**Response to**

**Request for Additional Information No. 221, Supplement 4**

**U. S. EPR Standard Design Certification**

**SRP Section: 06.02.01 - Containment Functional Design**

**Figure 06.02.01-15-1—Containment Pressure - 3” HL Break with Rupture Foils**

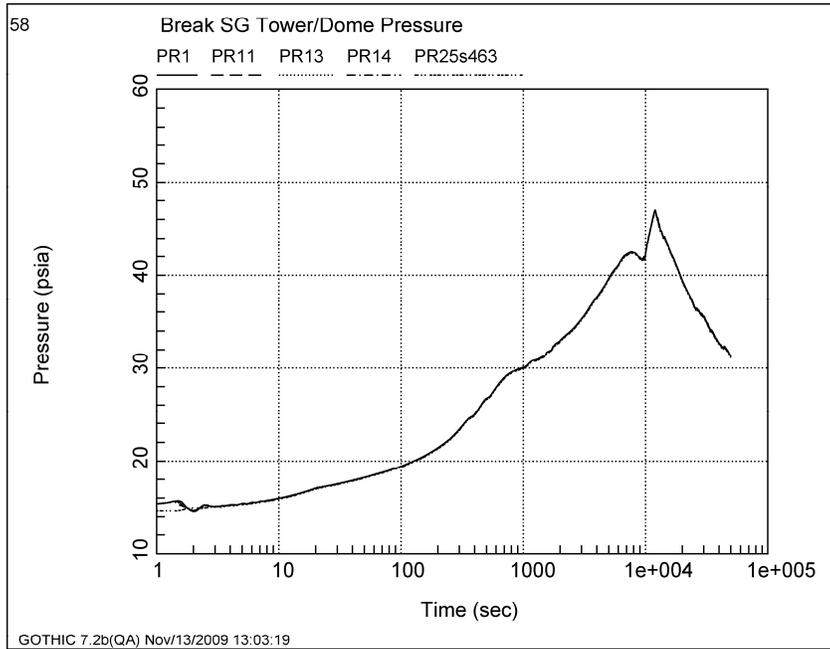
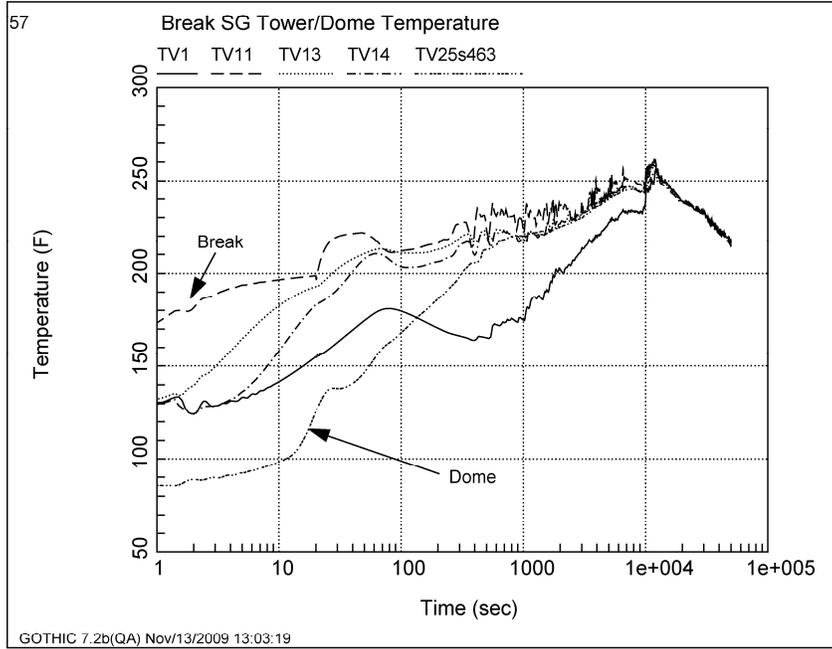
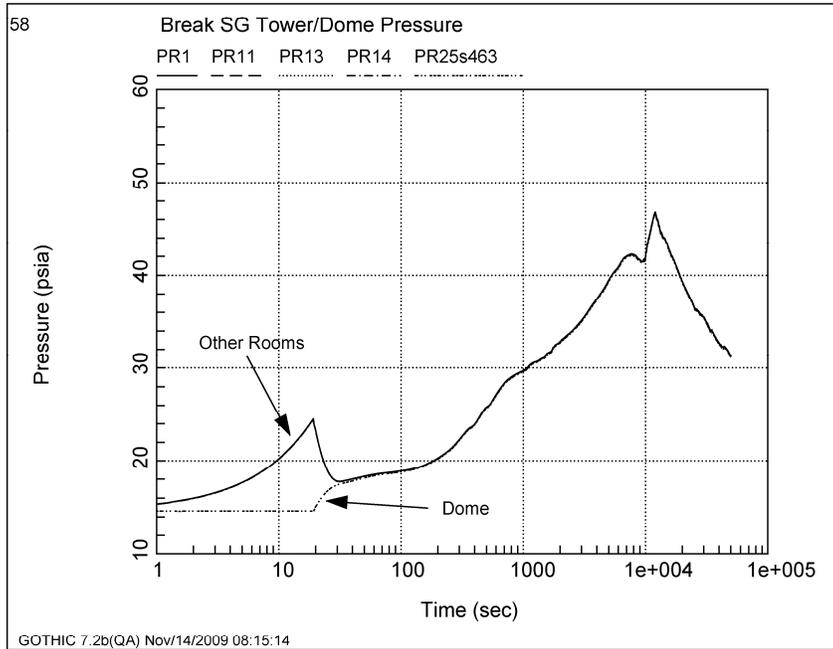
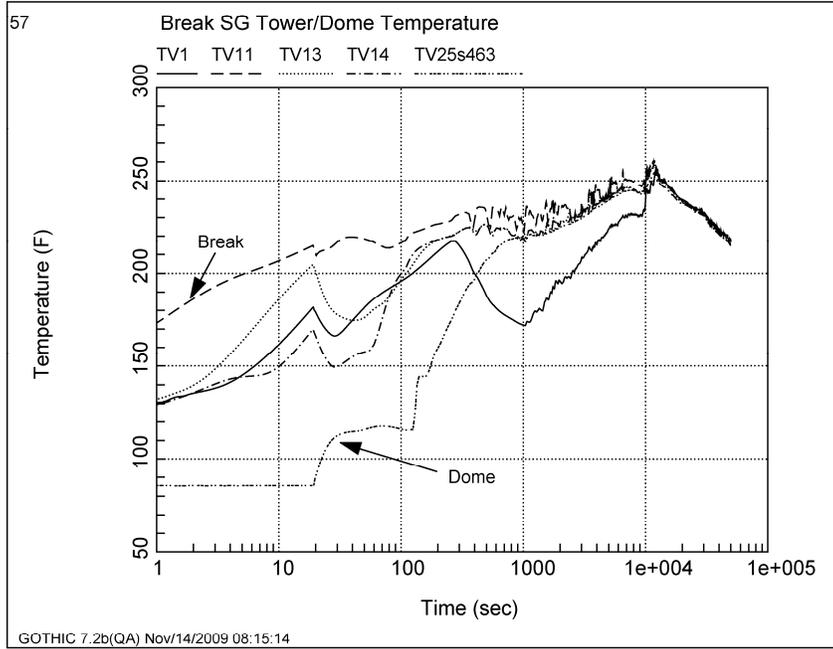
The last paragraph of Section 2.2 on page 2-10 of ANP-10299P states that the convection foils provide the minimum free-flow cross-sectional area needed to mitigate a small break LOCA event. Provide analyses of potential design basis small break LOCA events within the US-EPR containment to justify this conclusion.

To demonstrate that the free-flow, cross-sectional area of the convection foils is adequate to mitigate an SBLOCA, the three inch hot leg break was analyzed without crediting the rupture foils to open. Figure 06.02.01-15-1 through Figure 06.02.01-15-4 provide containment pressure and temperature response with and without credit for the rupture foils. The figures show that the long-term pressure and temperature response is similar for both cases and bounded by the large break loss of coolant accident (LBLOCA) response. In the short-term, the case that does not credit the rupture foils results in a local pressure rise adjacent to the break room. The pressure peak is less than 30 psia and is mitigated when the convection foils open.

**Figure 06.02.01-26-1—Gap Between Reactor Vessel and Internals Close to the Outlet Nozzle**

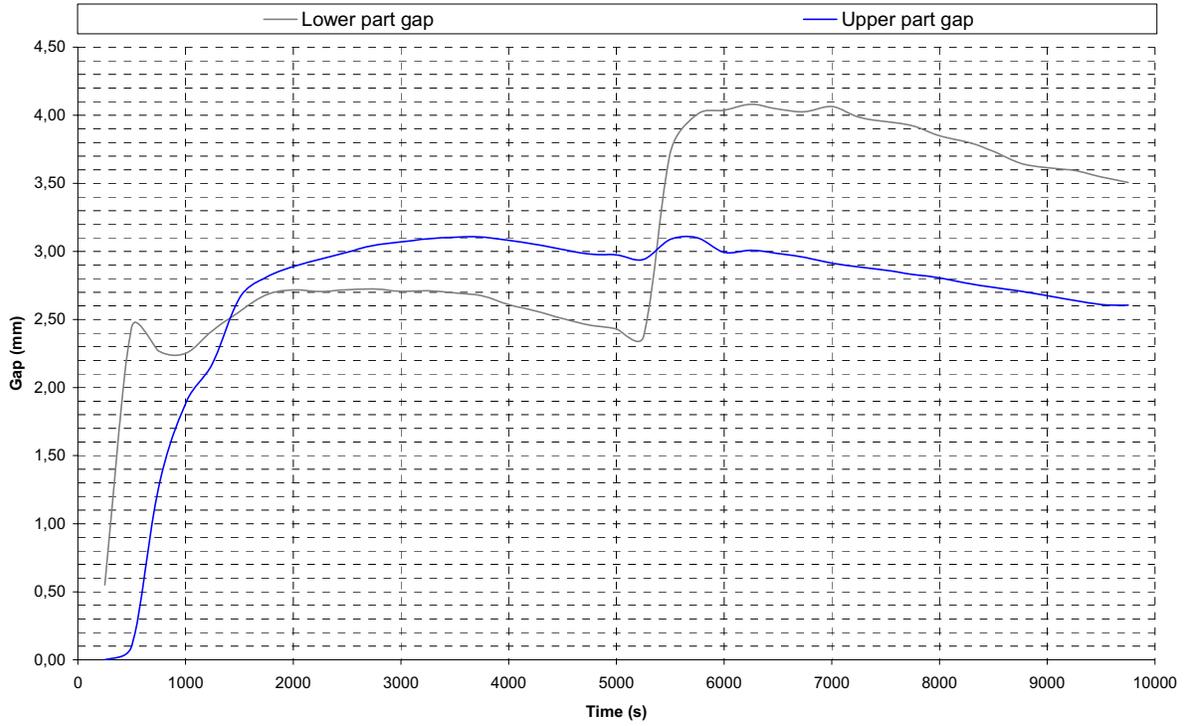
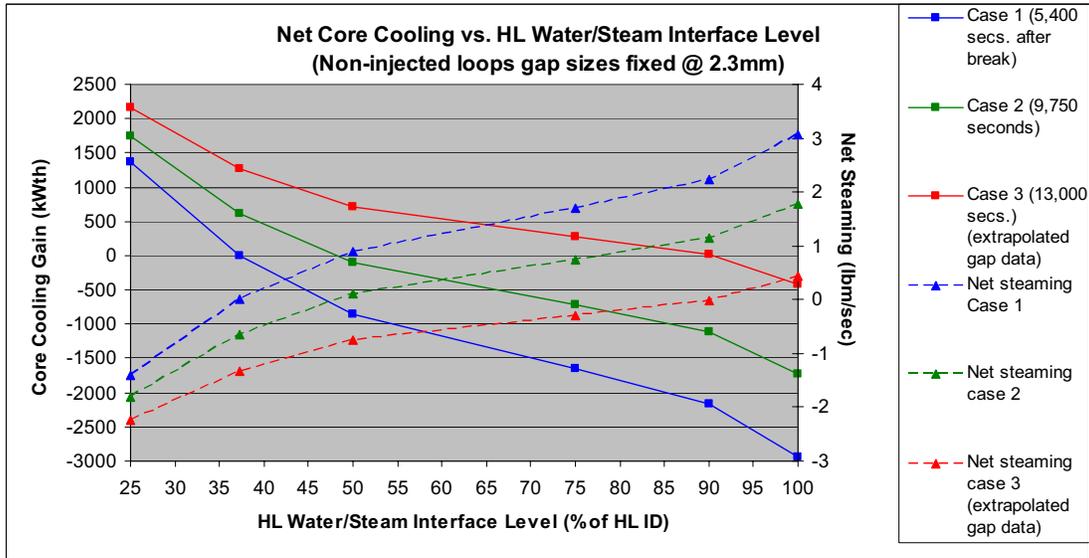
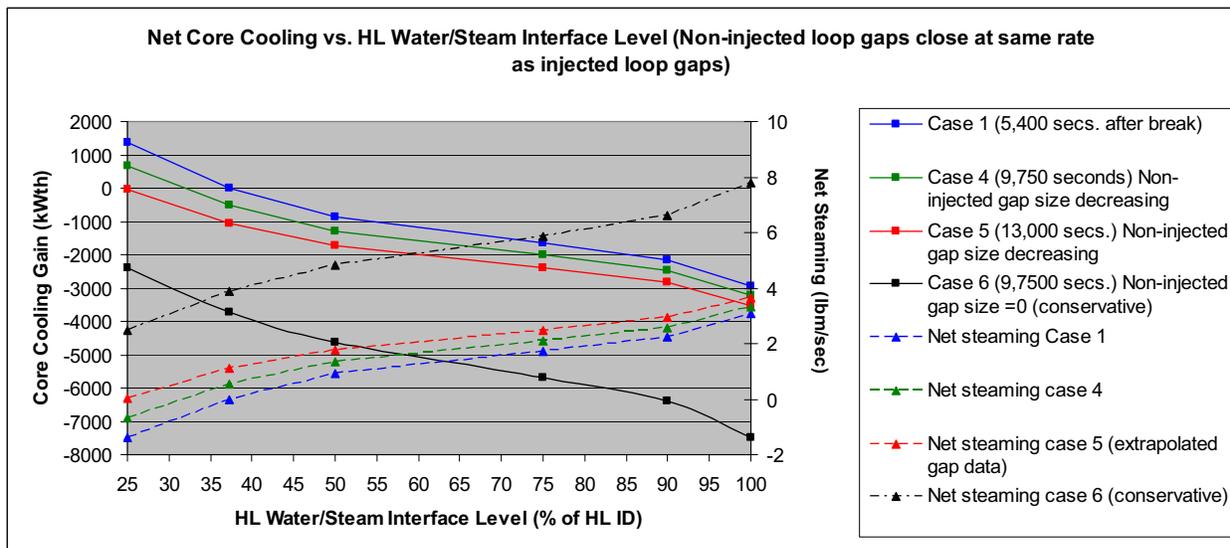
Section 5.3.1.5.6 of ANP-10299P discusses hot leg nozzle bypass and states that during later blowdown and early reflood phases, the thinner core barrel structure is cooled and the gaps grow to their maximum size. It is further stated that during the post-reflood phase the reactor vessel shell will cool and approach the pumped ECCS injection temperature but this may take several hours. The effect of hot leg injection is stated to have the effect of cooling portions of the core barrel faster than the reactor vessel shell and to keep the gaps open longer. Since the effect of hot leg nozzle gaps might have the effect of permitting hot leg injection to drain to the downcomer and thereby not be available for core mixing, provide an evaluation of this phenomenon showing its effect on steam condensation in the reactor vessel during hot leg injection.

Figure 06.02.01-26-1 shows gap data, from a thermal-stress analysis, as a function of time for a gap exposed to hot leg injection. A circumferential gradient in gap size exists after hot leg injection because the lower part of the gap is “cooler,” i.e., it is more directly exposed to the ECCS injection than the upper part, which is exposed to steam. For this analysis, a uniform

For the injected loop gaps, it is conservative to use the "lower part of gap" curve because it provides a larger average gap size. As gap size increases, both the cooling detriment and cooling credit effects of these gaps increase. Over most of the assumed range of hot leg level (except for lower levels) the detriment is larger than the credit. As gap size increases, the net detriment increases. Using the values for the "lower part of gap" for the injected loop hot leg gaps is conservative over most of the range of assumed hot leg levels. These "lower part of gap" values are approximated as closing at the rate of approximately 0.6mm/hour (based on the slope of "lower part gap" curve in Figure 06.02.01-26-1).

lb<sub>m</sub>/sec at 9,801 seconds. Figure 06.02.01-26-2 and Figure 06.02.01-26-3 show the sensitivity of gap size and hot leg water level on core cooling due to the presence of gaps.

**Figure 06.02.01-28-1—Temperature difference:- RPV intermediate shell – Lower downcomer**

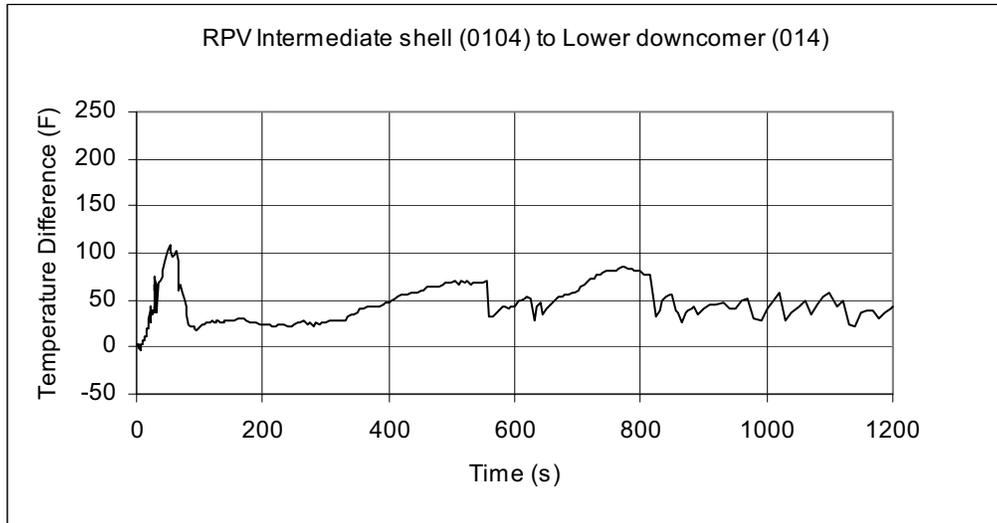
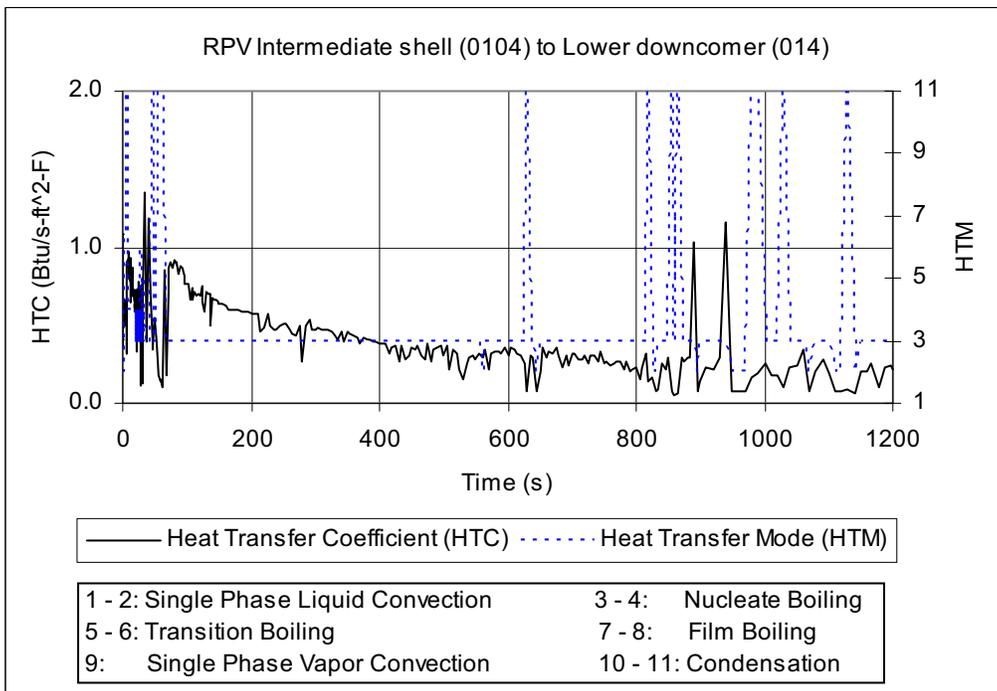
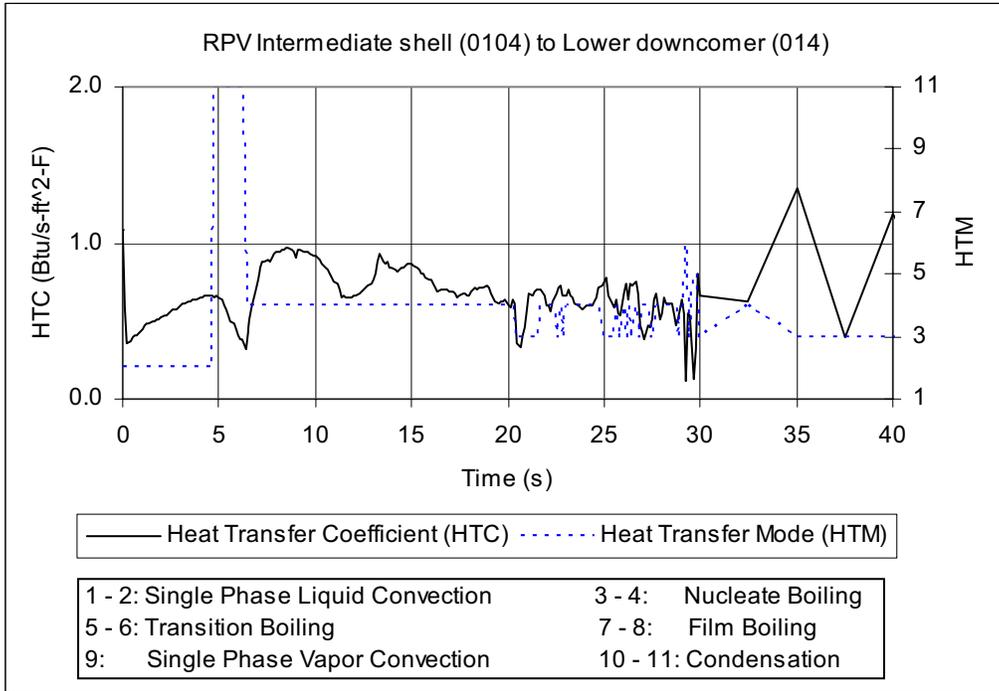
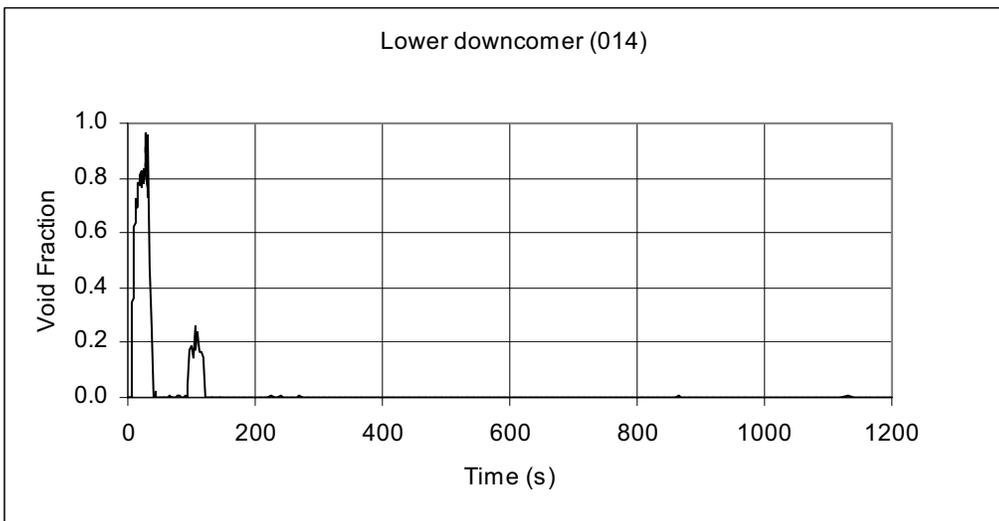
For the US-EPR containment calculation in Section 8 of ANP-10299P using the new EM model, provide the heat transfer coefficient as a function of time that is calculated between the reactor vessel shell and the downcomer fluid and the temperature difference to the downcomer fluid as a function of time. Indicate the mode of heat transfer that is occurring associated with the differential temperature and heat transfer coefficient plots. Discuss the conservatism of the RELAP5 calculated heat transfer compared to the nucleate boiling assumption recommended by the SRP.

For example, the parameters requested in this Question are provided for the RPV intermediate shell connected to the first section of the lower downcomer. Figure 06.02.01-28-1 shows the temperature difference between the RPV intermediate shell and the bulk fluid temperature. Figure 06.02.01-28-2 provides the heat transfer coefficient and mode number, showing that nucleate boiling is the major heat transfer mode in this section. Figure 06.02.01-28-3 shows that in the initial blowdown phase, the major mode of heat transfer is nucleate boiling. Based on the vapor fraction (Figure 06.02.01-28-4) and differential temperature conditions, single phase liquid convection, vapor condensation, and transition boiling exist for short durations during the initial blowdown phase, but the major heat transfer mode is nucleate boiling.

**Figure 06.02.01-30-2: Secondary Side Fluid Temperature for Test 21806**

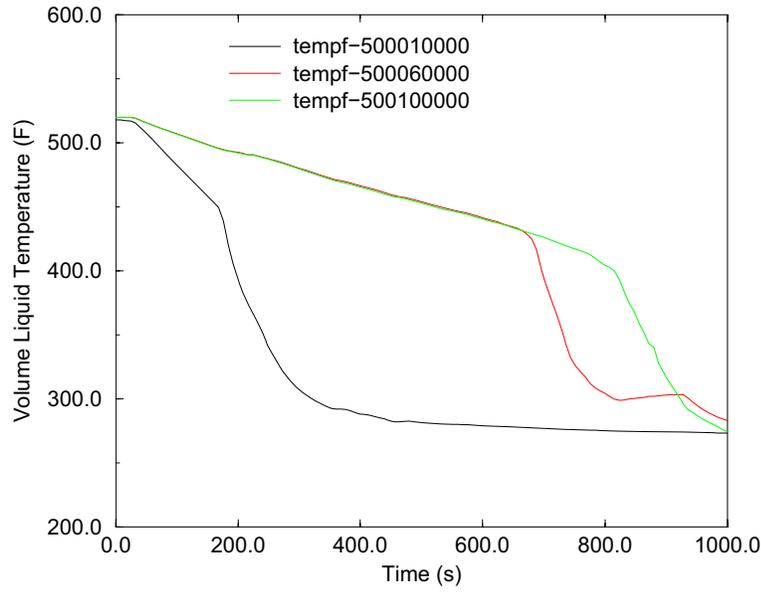
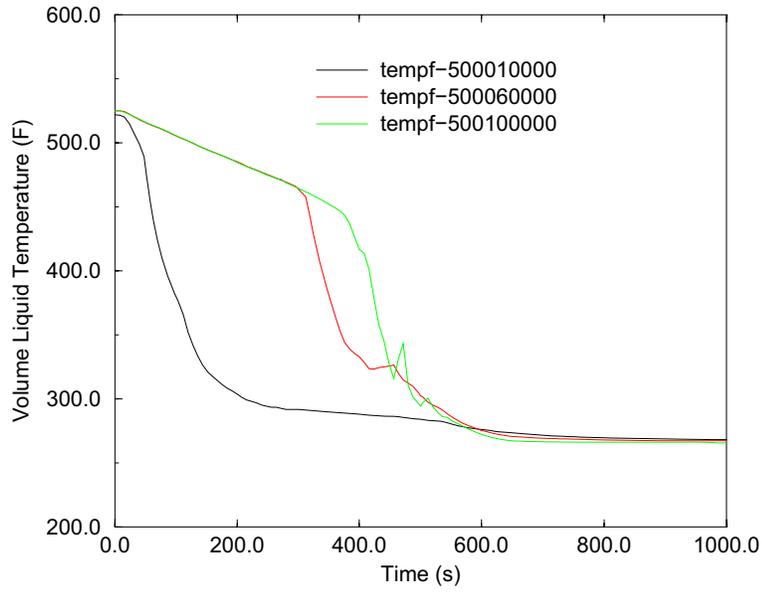
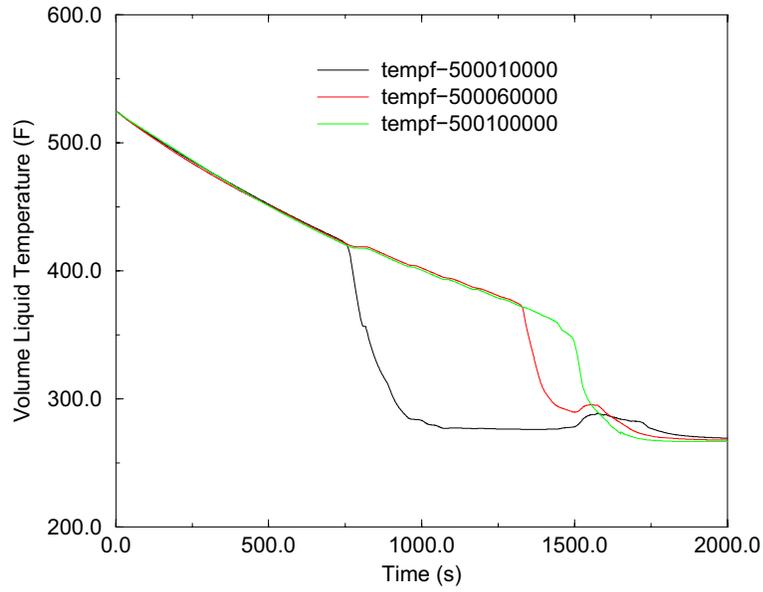
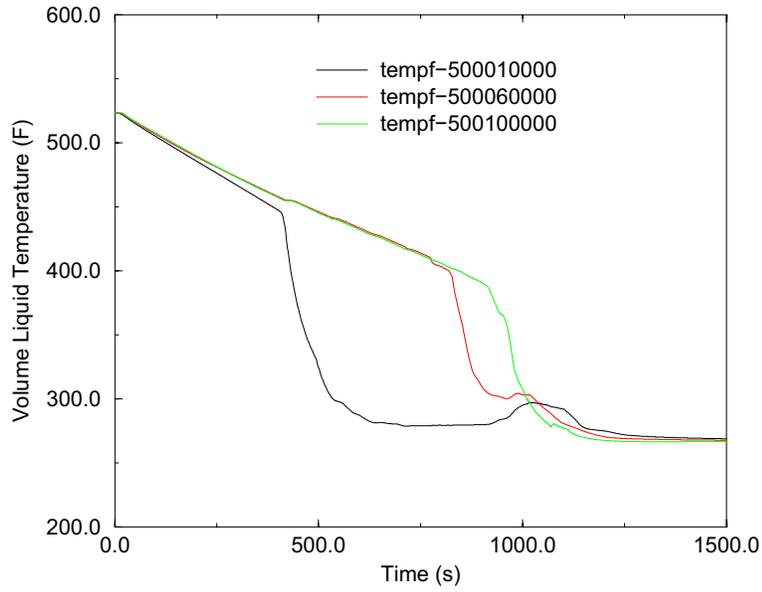
Section 6.1.3 describes calculation of steam generator heat transfer by RELAP5-BW. Predictions for FLECHT-SEASET tests are presented which show good agreement when the test facility is modeled. The prediction of steam generator heat transfer appears to be a function of the steam and liquid flow rates within the steam generator tubes. For the US-EPR containment analysis with the new EM model in ANP-10299P show that with the predicted steam generator tube flow rates that the heat transfer predicted for the US-EPR is conservative based on comparison to experimental data.

Figure 06.02.01-30-2 through Figure 06.02.01-30-5 show the fluid temperature on the shell side for the benchmarked FLECHT SEASET tests at the entrance, middle, and top of the tube. For the FLECHT SEASET benchmarking tests, it was assumed that the inlet and outlet shell sides have uniform temperatures.

A comparison of FLECHT SEASET tests #21806 through #22314 in Table 06.02.01-30-2, and Figure 06.02.01-30-2 and Figure 06.02.01-30-4 shows that the heat transfer decreases as quality increases.

**Figure 06.02.01-34-1—Comparison of Gas Flooding Limit Curve to Sample Problem Condition at Inlet to CL PS Upside Loop Seal**

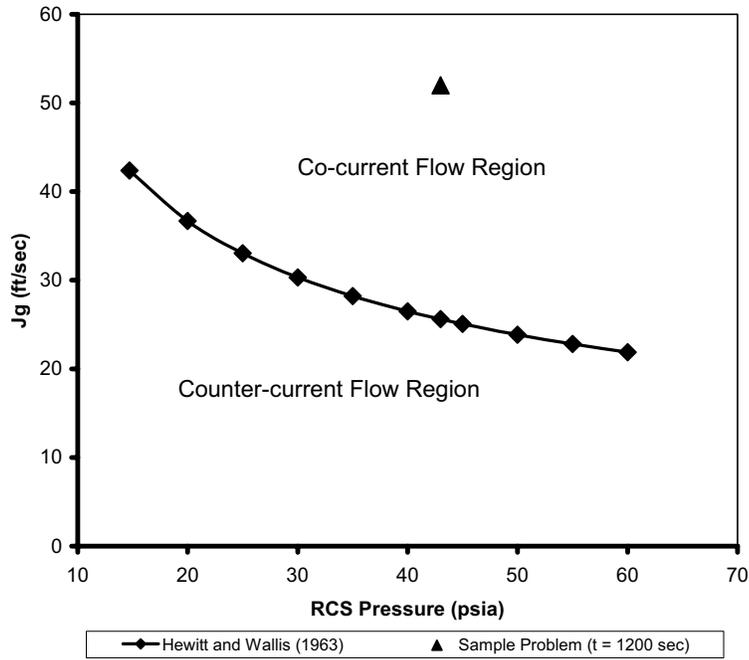
For the new EM containment M&E model described in Chapter 8 of ANP-10299P, RELAP5-BW is used to calculate the break flow to the containment until the containment loop seals are assumed to fill with water. After the loop seals are assumed to have filled, the GOTHIC code is utilized to calculate the break flow to the containment. Provide justification for the time selected for loop seal closing. Would an earlier time result in a higher containment pressure prediction?

The gas flooding limit curve generated by equation (1) with  $C=0.725$ , and the other inputs regarding tube size (2.57 ft) and liquid flow (440 lbm/sec), is shown in Figure 06.02.01-34-1. The liquid flow at these conditions (440 lb<sub>m</sub>/sec and 62 lb<sub>m</sub>/ft<sup>3</sup>) corresponds to a liquid superficial velocity of 1.363 ft/sec. In addition to the limit curve, this plot depicts the data point representing the RELAP5 calculated steam flow condition at 1,200 seconds, namely steam superficial velocity of 52 ft/sec at reactor coolant system (RCS) pressure of 43 psia.

Figure 06.02.01-34-1 shows that the data point representing the RELAP5 calculated steam flow condition at 1,200 seconds falls in the cocurrent flow regime. This indicates the flow pattern in the CLPS upside loop seal at 1,200 seconds favors “sweep-out” or entrainment of the liquid film by the steam flow originating in the core, preventing the ECCS liquid from reaching the cross-over leg and filling it.
